Technical Service Information

FORD 4F27-E MAZDA FN4A-EL 1-2 FLARE AND 3-4 NEUTRAL

Figure 1

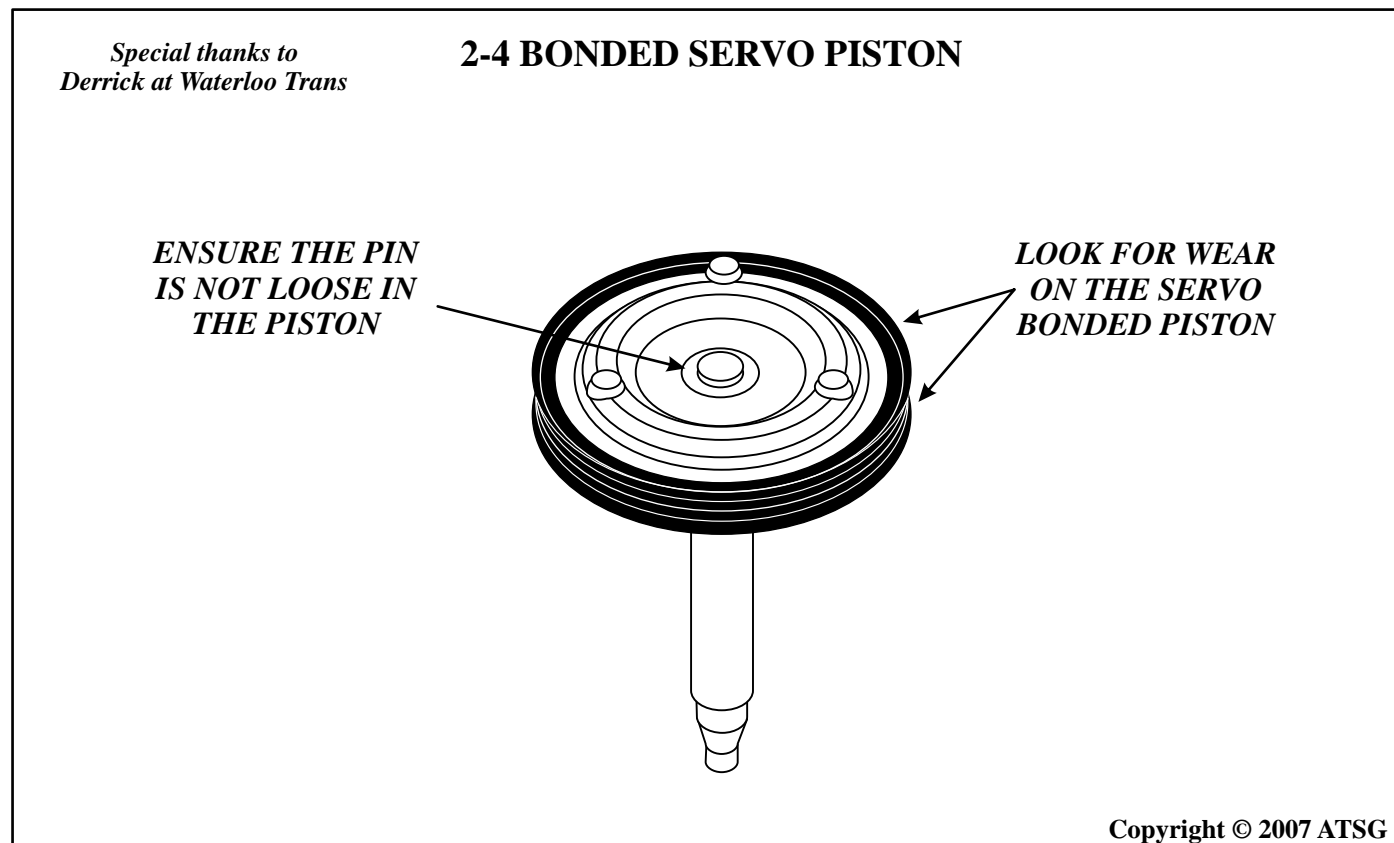
CAUSE: The cause may be, the bonded 2-4 servo piston is worn or the pin is loose from the piston, as shown in Figure 1. The cause for the piston being worn is because of a rough surface in the servo bore in the case.

CORRECTION: Replace the 2-4 servo piston, as shown in Figure 1. Using some fine sand paper or scotch-brite, lightly sand the bore of the case where the bonded rubber part of the servo rides, to ensure that is smooth. See Figure 2. Re-assemble the servo assembly back into the case as shown in Figure 3. **NOTE: If this repair is attempted in the vehicle, the linkage which is right over the 2-4 servo piston, will have to be removed, which means the mount bolts will have to be removed and the transmission lowered in the vehicle.**

2-4 BONDED SERVO PISTON (Ford part number).....XS4Z-7D021-AB
